WEDGWOOD CENTER DEVELOPMENT

Early Design Guidance - 2

SDCI # 3040032-EG

10/28/2024

Study 2:
Two Way + No Parking + Court

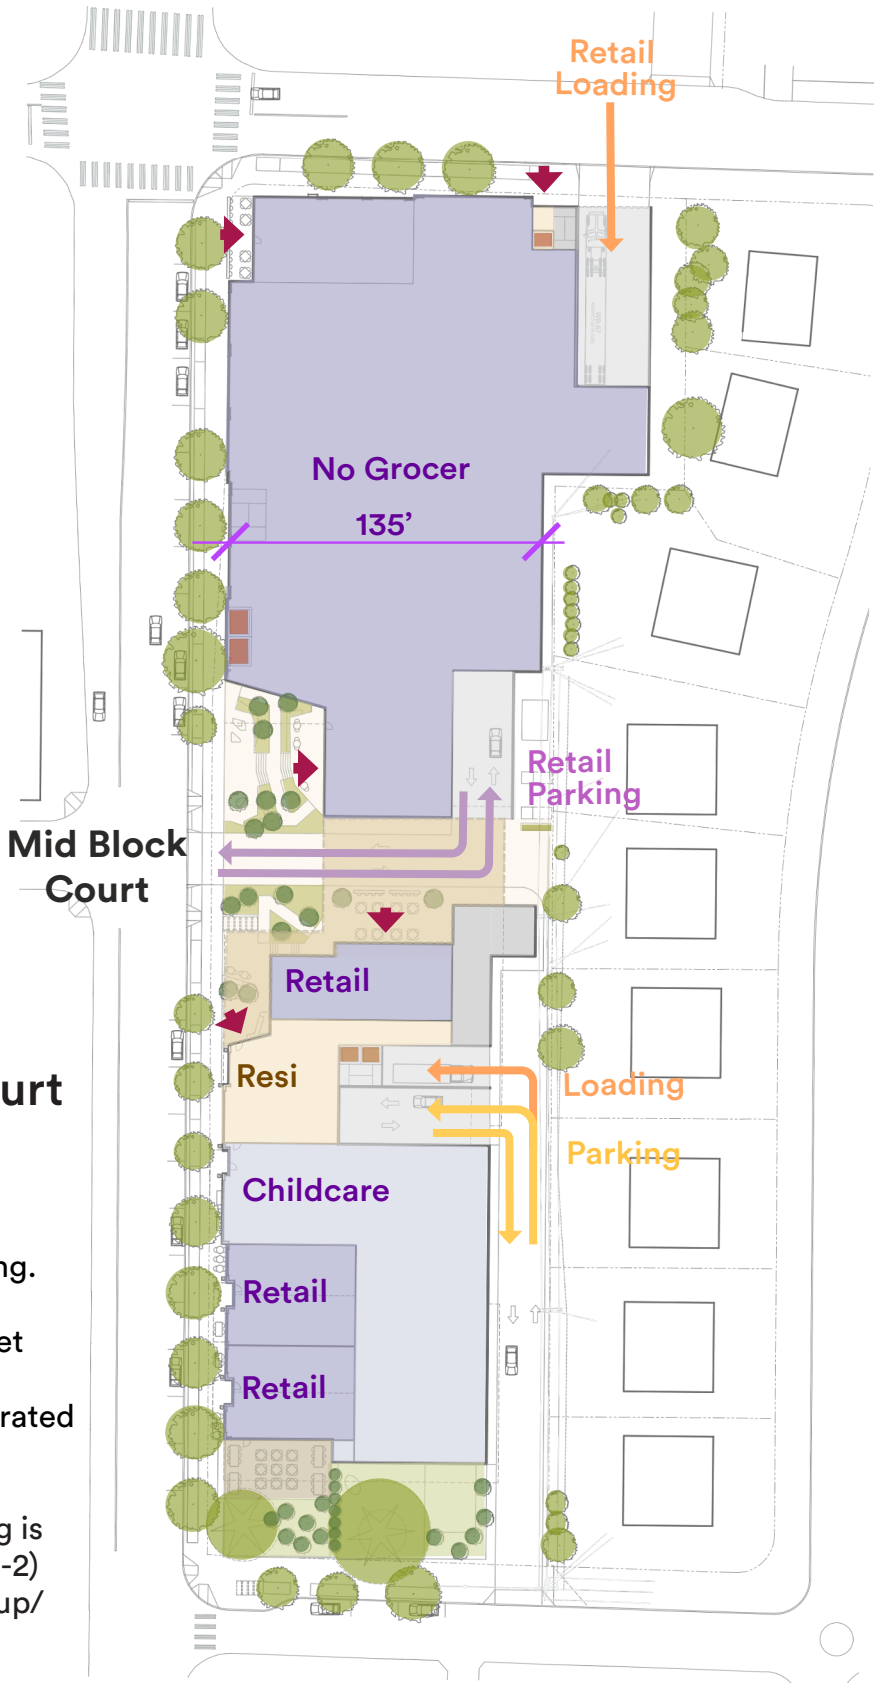
B. Request for further study of circulation options at the Mid-block Court

- Maintains two way circulation through the midblock court and removes surface parking.
- Northern retail depth is not feasible.
- No grocer. Parking & circulation do not meet requirements.
- Northern retail provides too much concentrated retail SF for the neighborhood.
- Retail buried in court is not feasible.
- Additional outdoor seating and landscaping is provided at Mid Block Court (PL3-A-B, PL3-2)
- No convenience parking for childcare pickup/drop off

Study 3:
One Way + Parking + Court

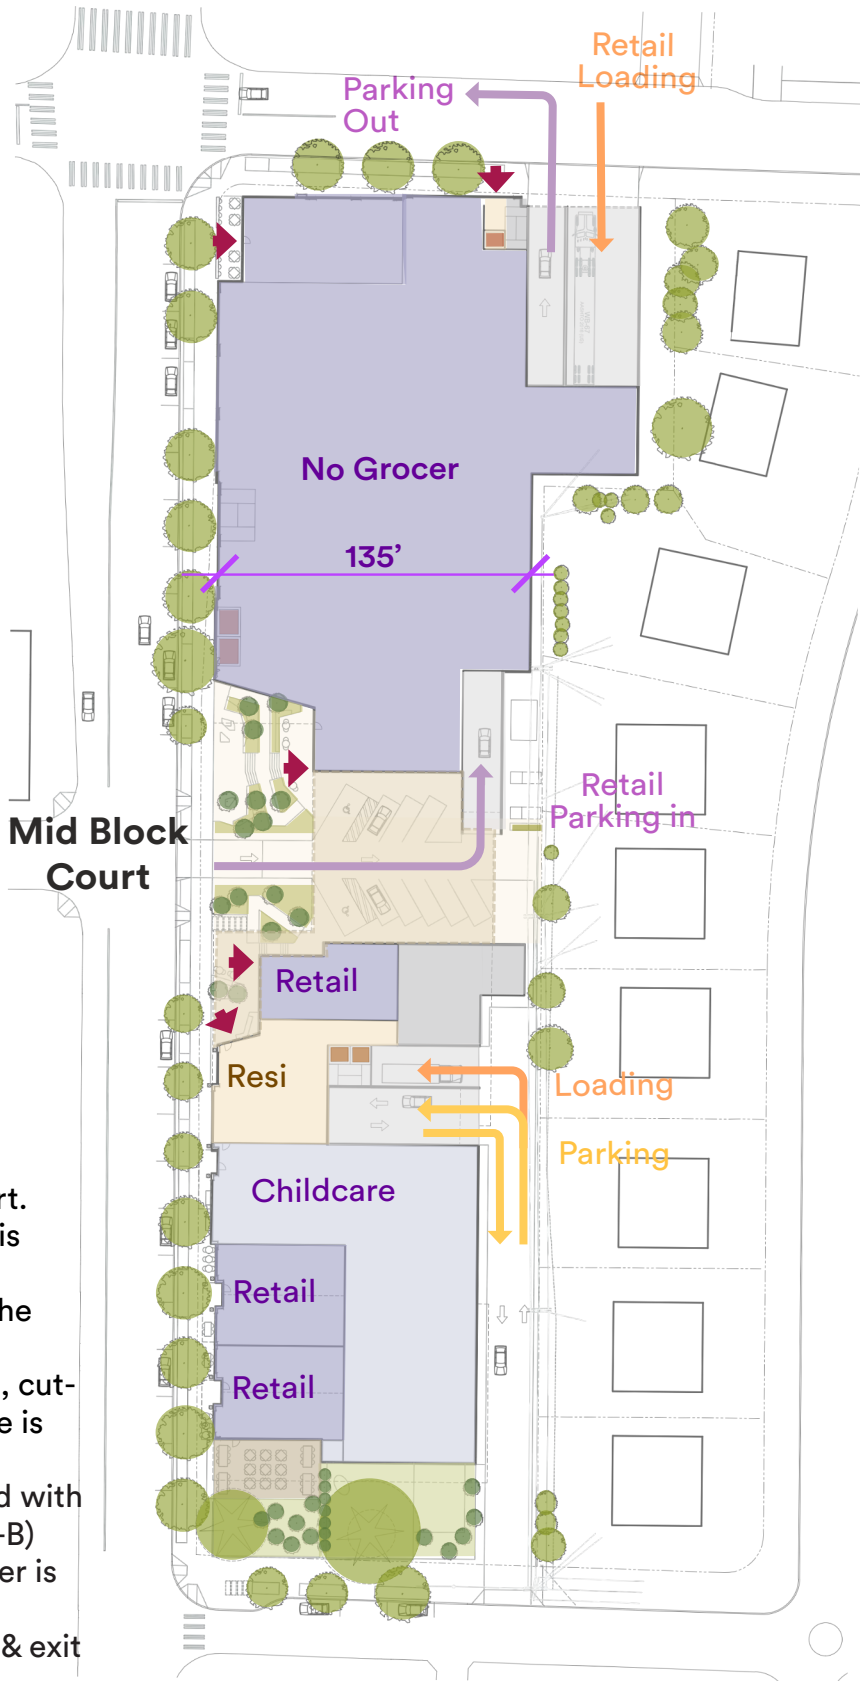
B. Request for further study of circulation options at the Mid-block Plaza

- One Way circulation through mid block court. The curb cut along 85th is over 55' wide and is unsafe (DC1-B-1)
- Vehicle queuing on 85th could back up into the intersection of 85th and 35th.
- With dual access points to/from the parking, cut-through traffic from 82nd to 85th when 35th Ave is busy poses a concern.
- Outdoor seating and landscaping is provided with relief from streetscape (PL3-A-B, PL3-2, PL1-B)
- Convenience parking for childcare and grocer is provided
- Grocer requires multiple vehicular entrance & exit points. One-way circulation does not meet requirements.

EDG-2 Proposed Driveway at Mid-block Plaza

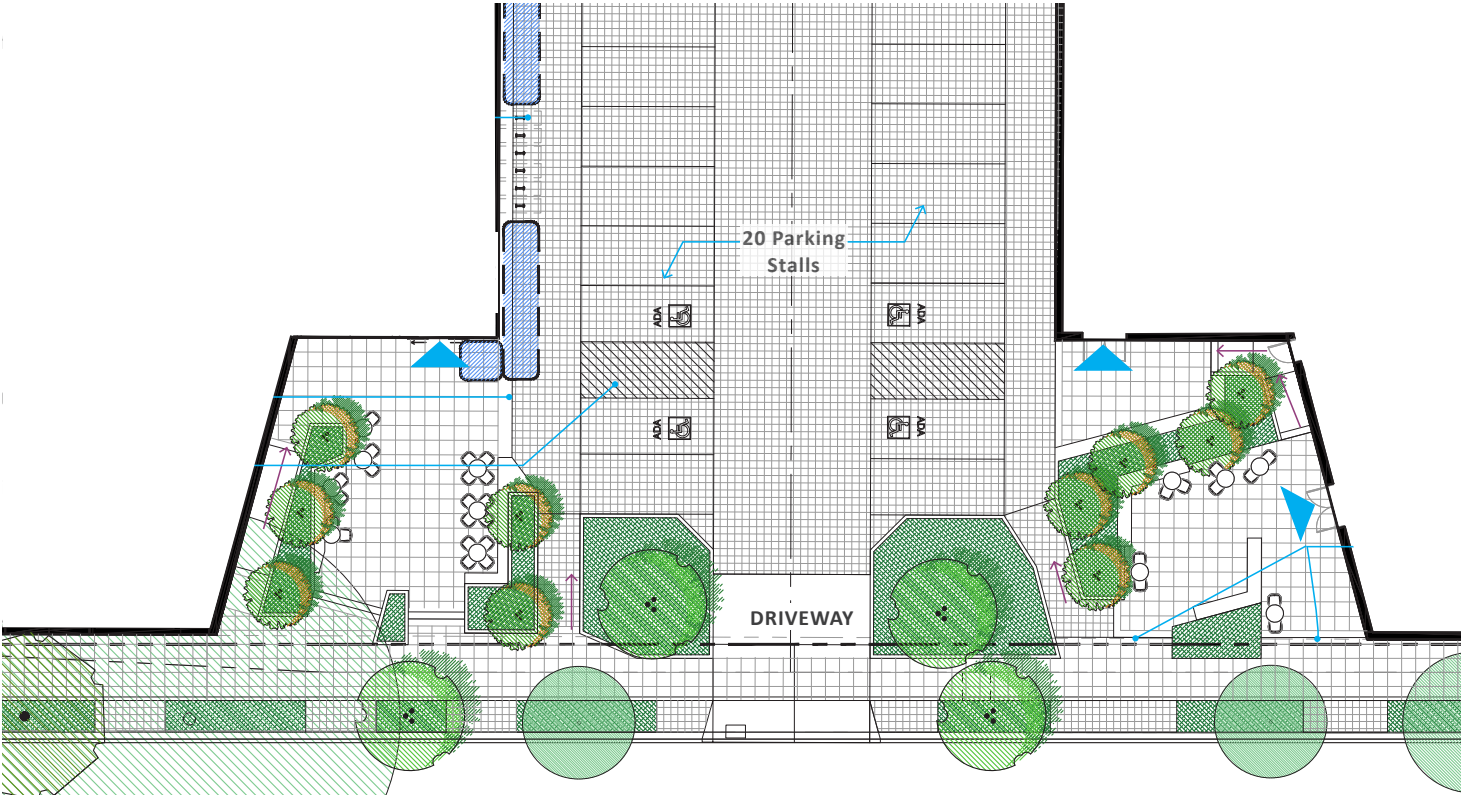
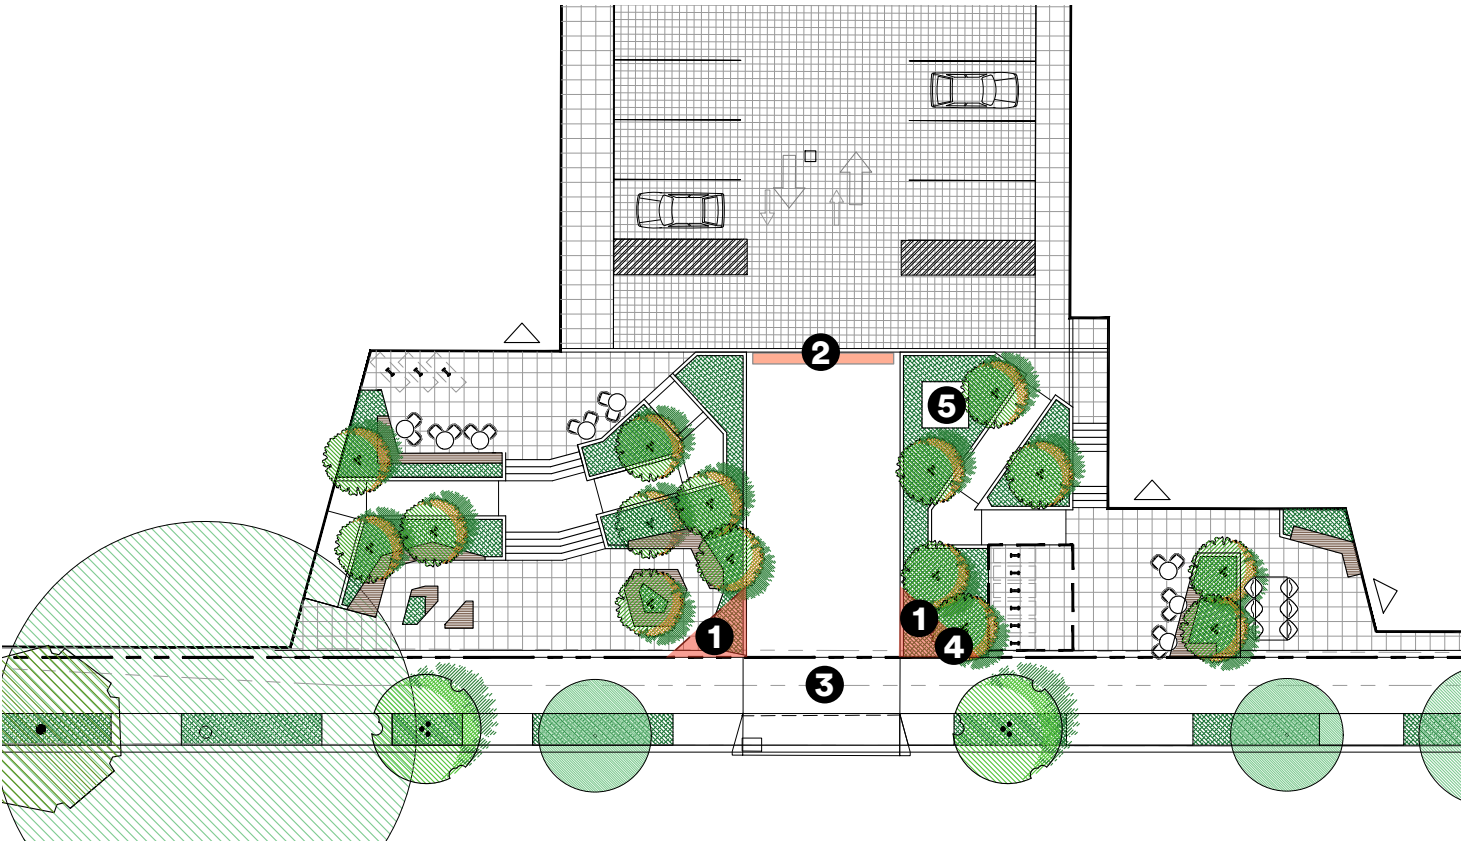
- C. **Request** for additional study of elements of the Mid-block Court including:
- i. Covered/Open parking zone
 - ii. Extent of retail into the Mid Block Court area

The Board noted they would prefer to see more area open to the sky to allow in more daylight. They also voiced concerns regarding pedestrian safety as well as opportunities for pedestrian activation with active vehicle circulation crossing the sidewalk and in the ‘plaza’.

In alignment with the Seattle Design Guidelines, driveway use is maximized (DC1-B), and where the curb cut is provided, safety measures are a primary focus including those listed below:

- Light bollards
- Signage will be provided at all applicable conditions
- Low plantings such that visibility is not obscured will be provided near the vehicular access points from 35th Street & 85th Street
- Speed bumps will be provided at the vehicular access from 35th Street as an additional preventive measure to ensure pedestrians and vehicles both may safely use the court.

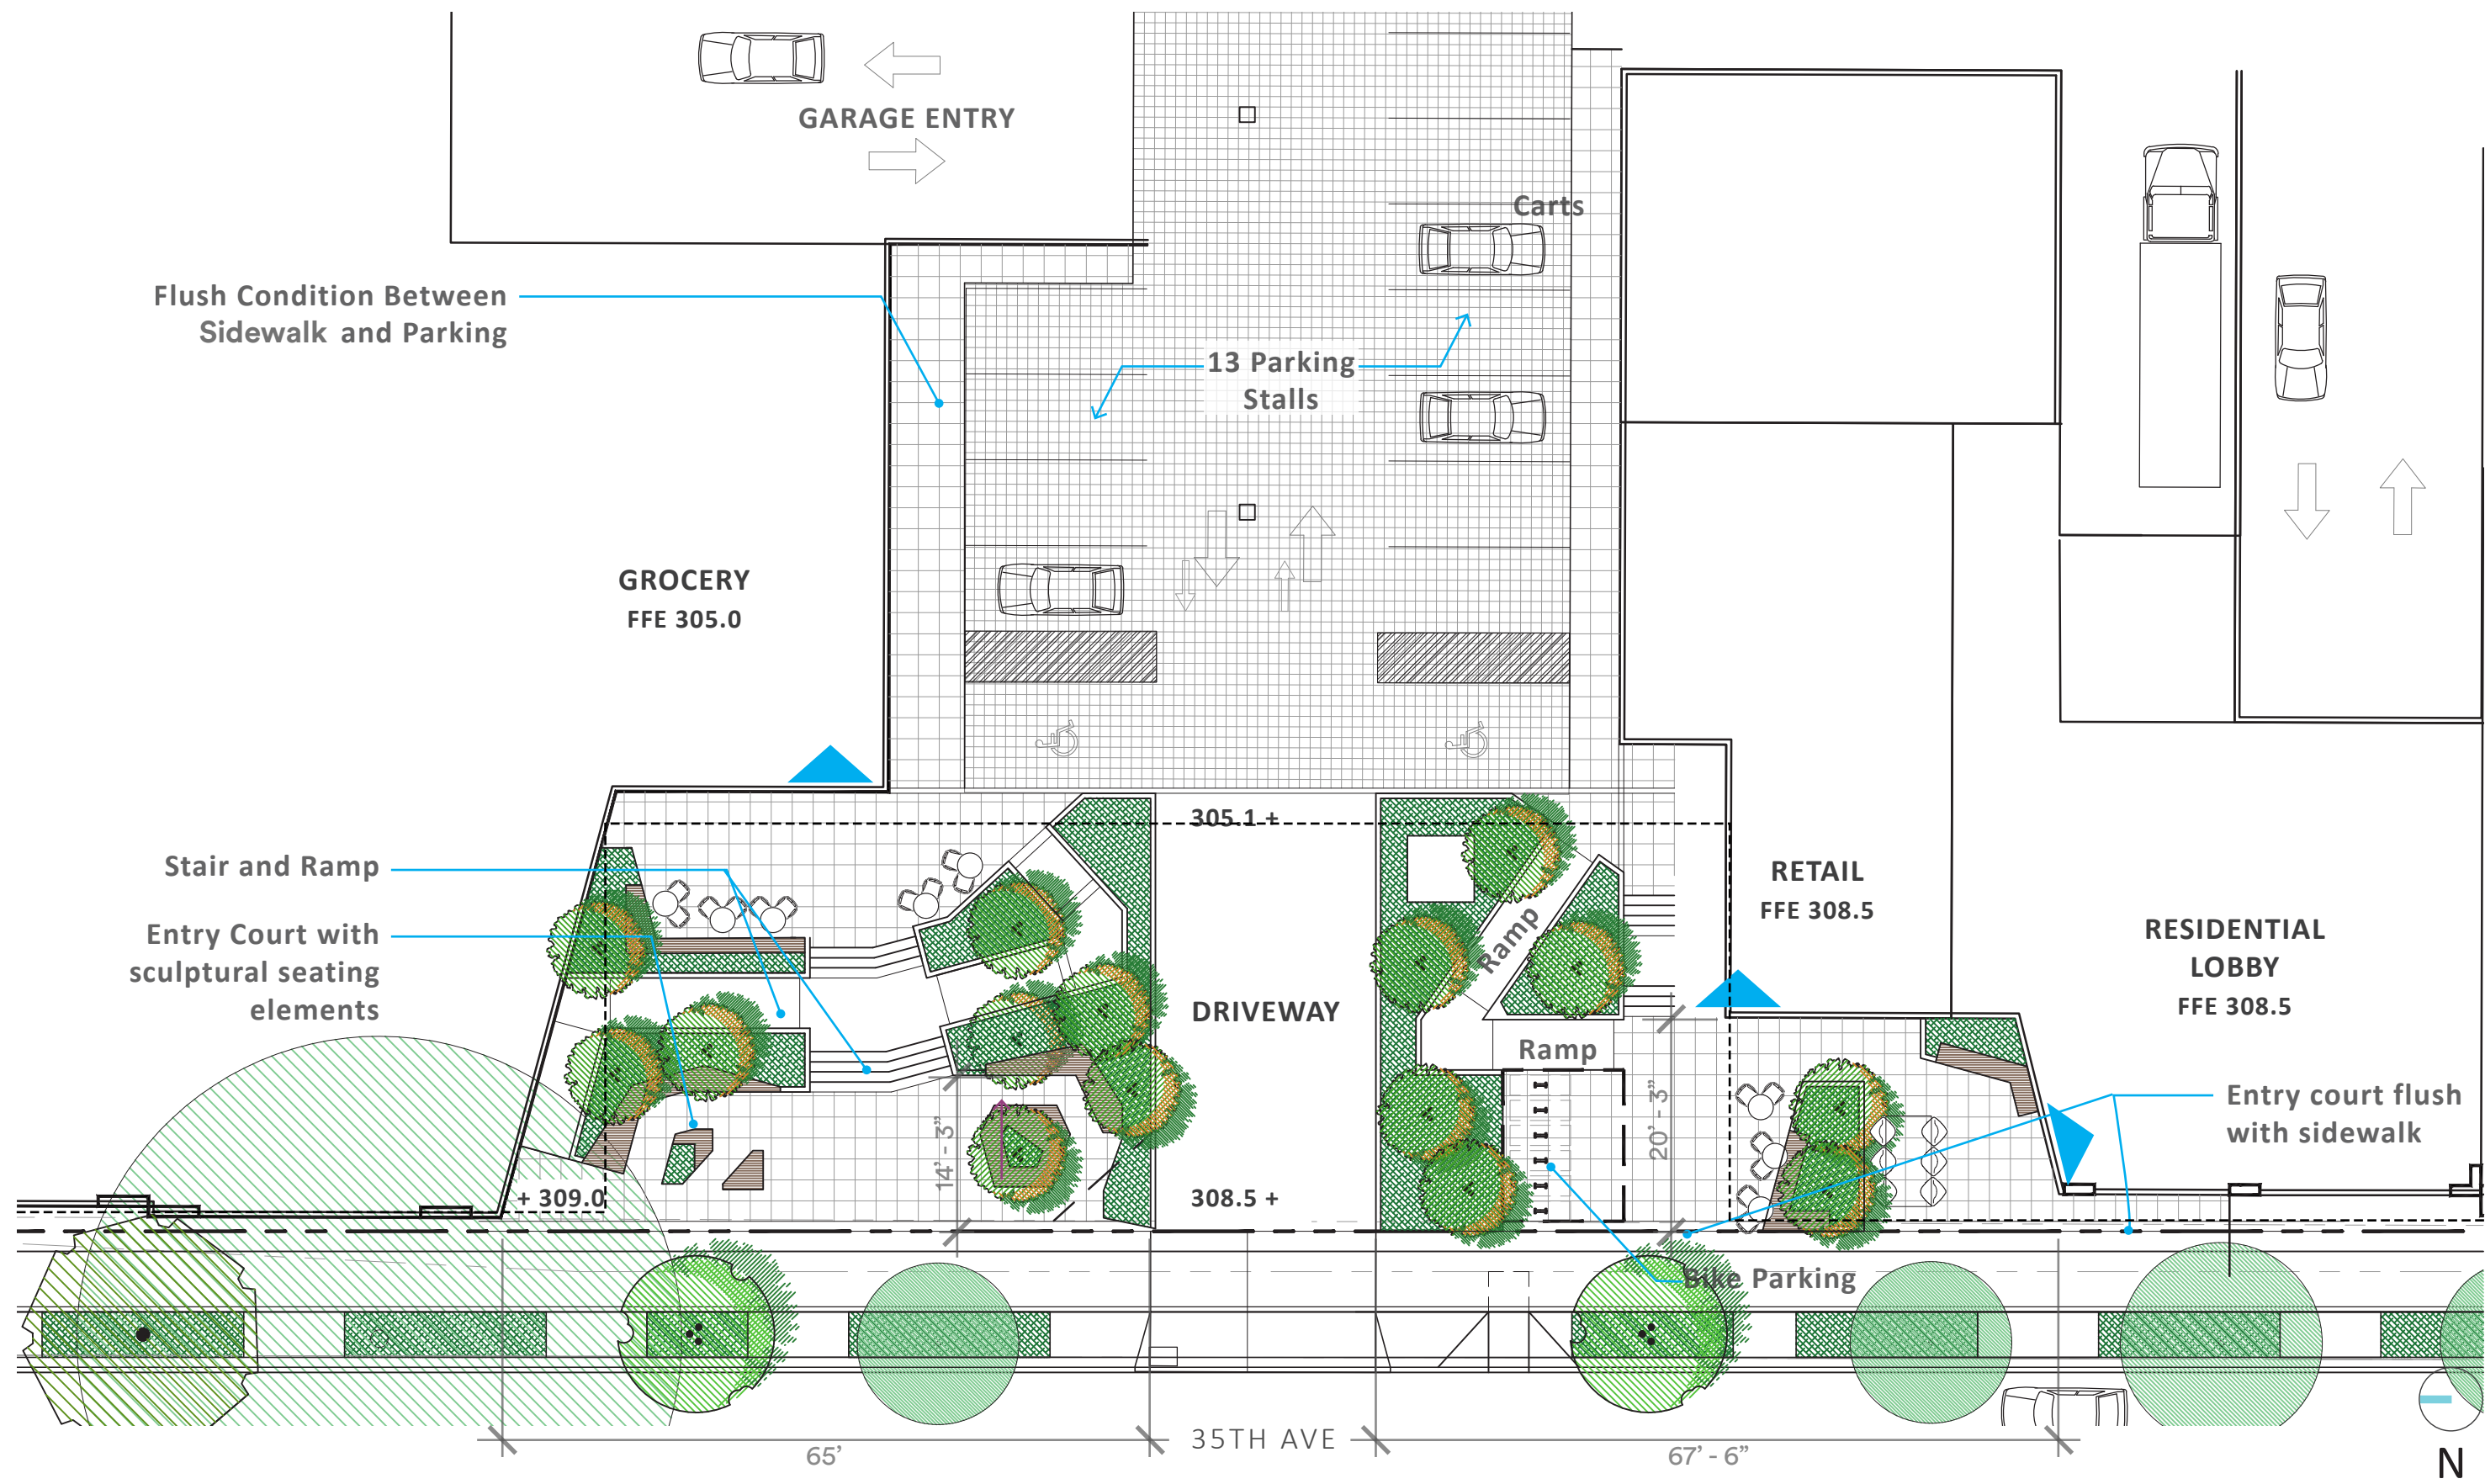
- C. Request for additional study of elements of the Mid-block Court including
- i. Covered/Open parking zone
 - ii. Extent of retail into the Central Court area

Since EDG 1, we made the court and open to the sky area larger in the center of the development - as indicated in green - while reducing the number of parking spaces. We’ve also added a retail space along the Mid-block court.

Decreased Covered area by 13%
Reduced Convenience Parking spaces by 33%

EDG 1 - Massing Concept C looking Northwest

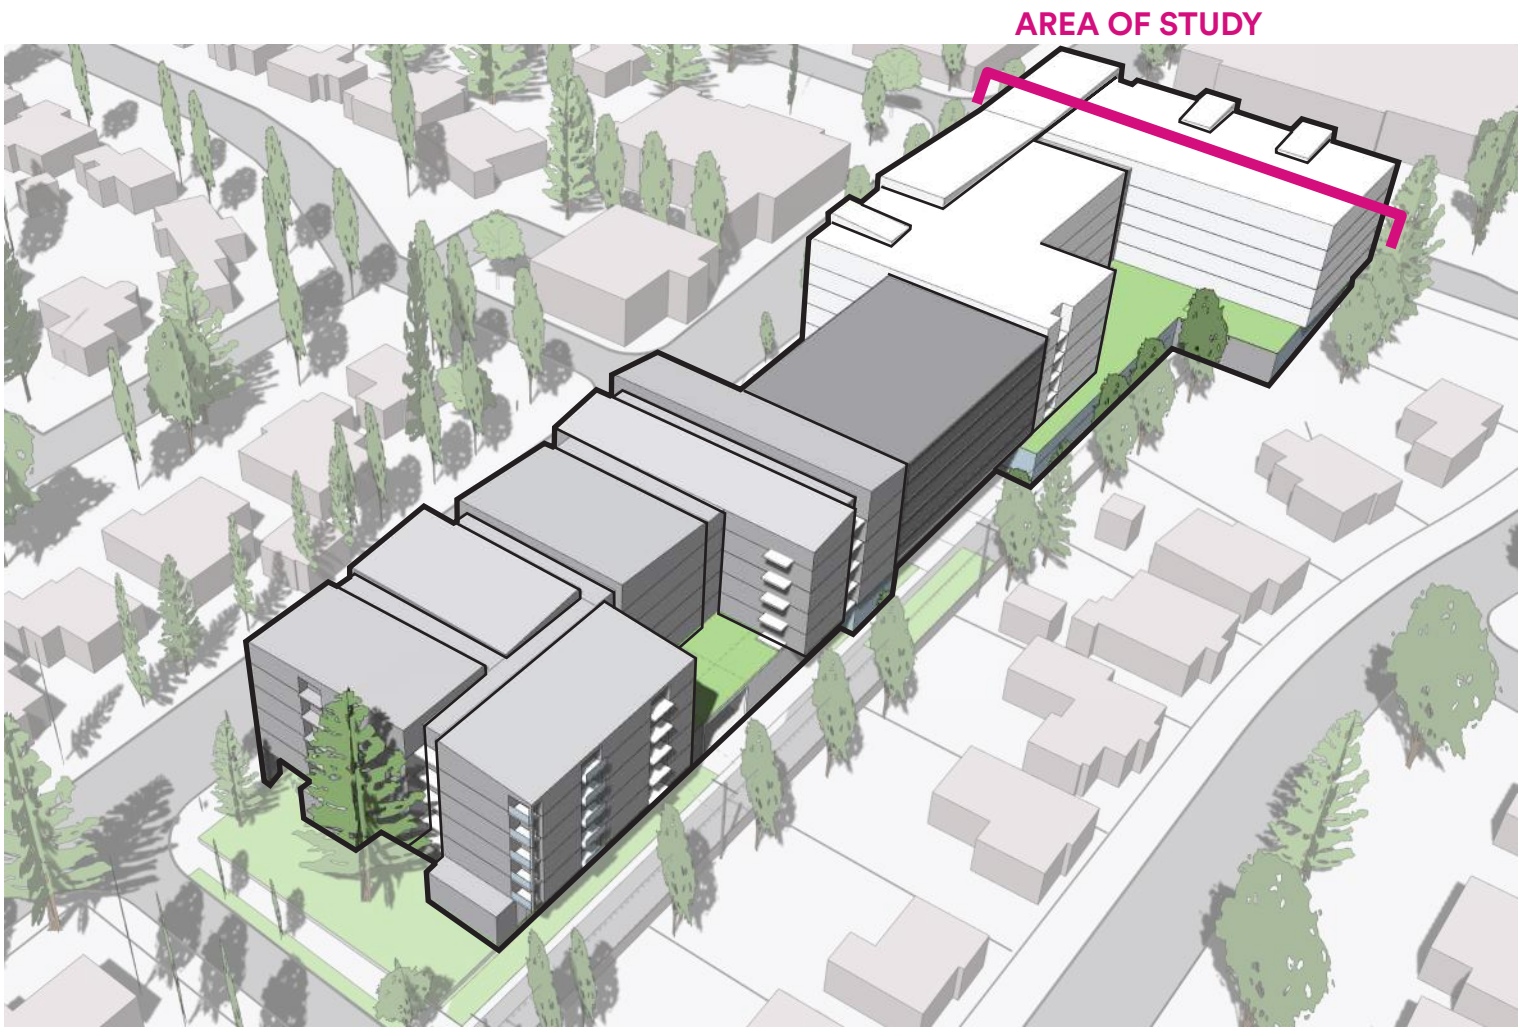
B. **Request for** more study of the massing transition along the north facade to the east facade at the zone transition.

The Board noted that the north façade, and especially the northeast corner of the building, was not clearly illustrated in the packet. They requested more information on this massing, specifically how the massing transitions along the north facade around to the east facade at the zone transition.
